SCHWEIZER SERVICE BULLETIN

B-294
24 Aug 2010

SUBJECT: INCORRECT BUSHING USED IN 269C FLIGHT CONTROLS

MODELS AFFECTED: • 269C Model Helicopters Serial No. S1166 & Subs.

Figure B-294-1. Flight Control Inspection Points

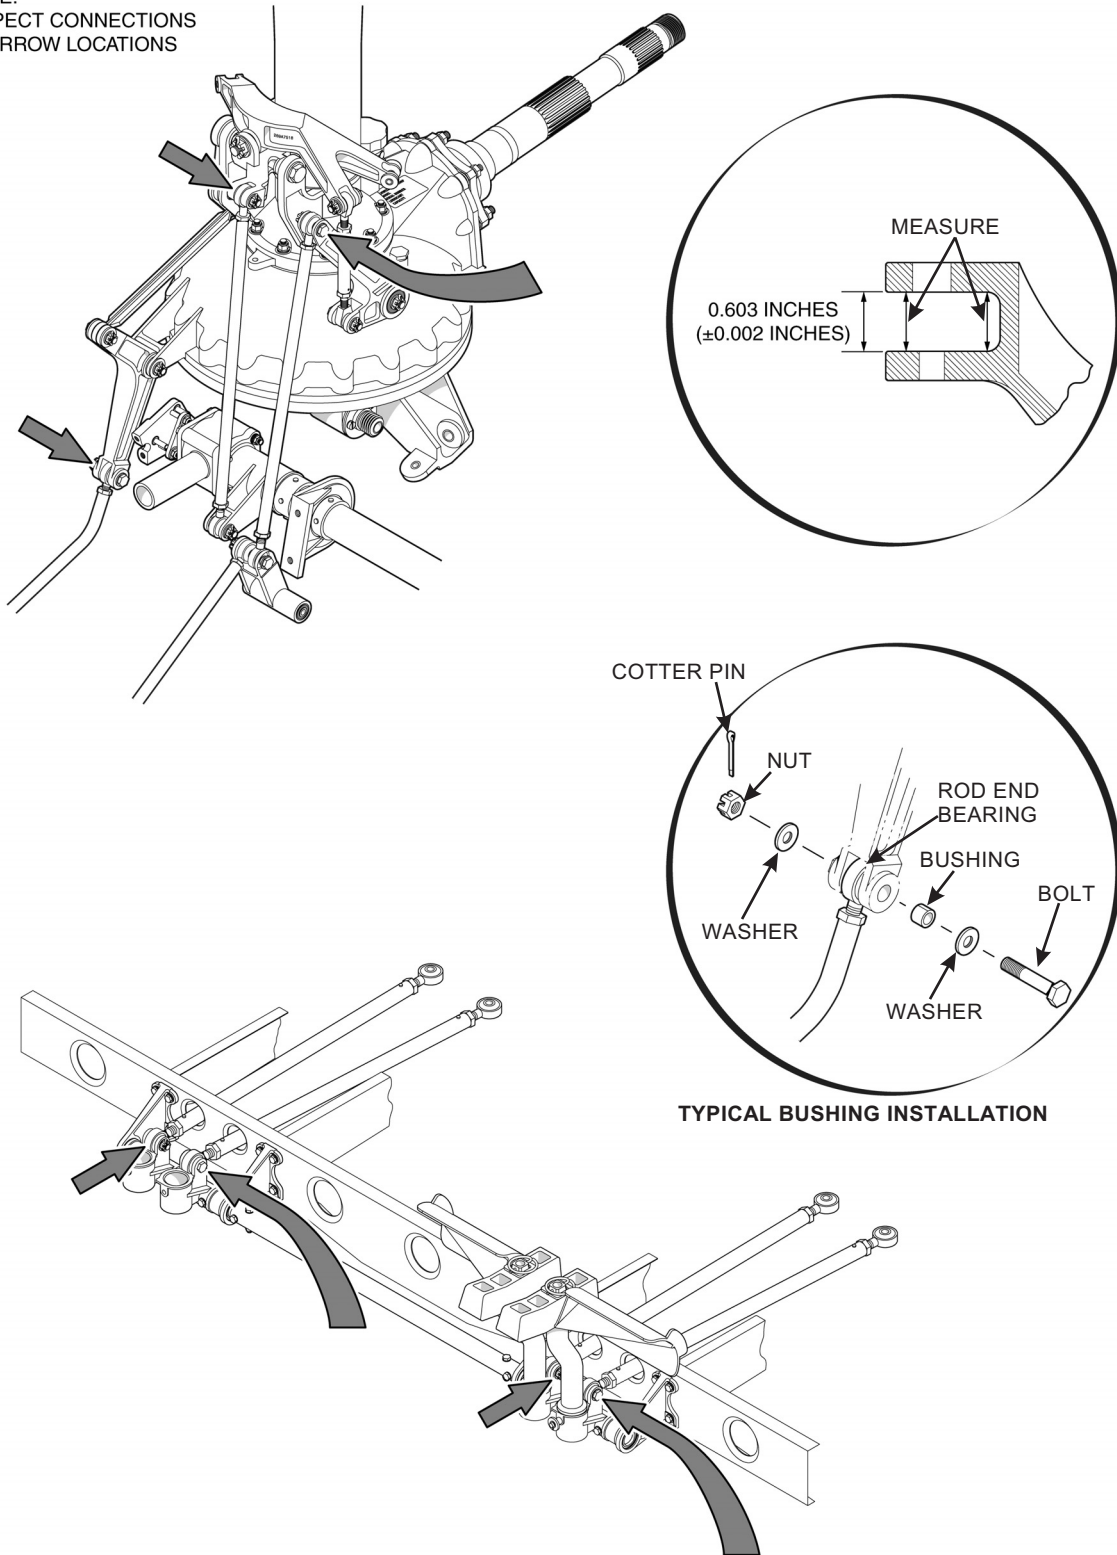
- a. Review Figure B-294-1 and note locations of all SHS626-4-313 bushing installations.

At installation, the SHS626-4-313 bushings are designed to be longer than the thickness of the bellcrank lug. When torqued, the bushing should contact the bearing rod end and extend above the bellcrank outside surface, keeping the washer from touching the bellcrank. If the washers on both sides of the fork are in contact with the fork, the incorrect bushing is installed.

- b. Gain access to all flight control rod connections containing SHS626-4-313 bushings and using a bright light and as required a mirror, inspect assemblies for installation of correct length slotted bushing.

If the incorrect bushing has been installed when the hardware is torqued, the legs of the forks will be drawn to the inner race of the rod end bearing. This can cause permanent distortion of the fork legs that can lead to cracks at the root end of the legs.

- c. If incorrect bushing is installed, remove bellcrank. Using Vernier calipers, check that the inside surfaces of the fork legs in two locations measure $.603 \pm .002$ (Figure B-294-1) and are parallel to each other. If surfaces are parallel, perform a dye penetrant inspection in accordance with Basic HMI Section 2. Remove from service and destroy any bellcrank found to have distorted or cracked legs.

NOTE:
INSPECT CONNECTIONS
AT ARROW LOCATIONS
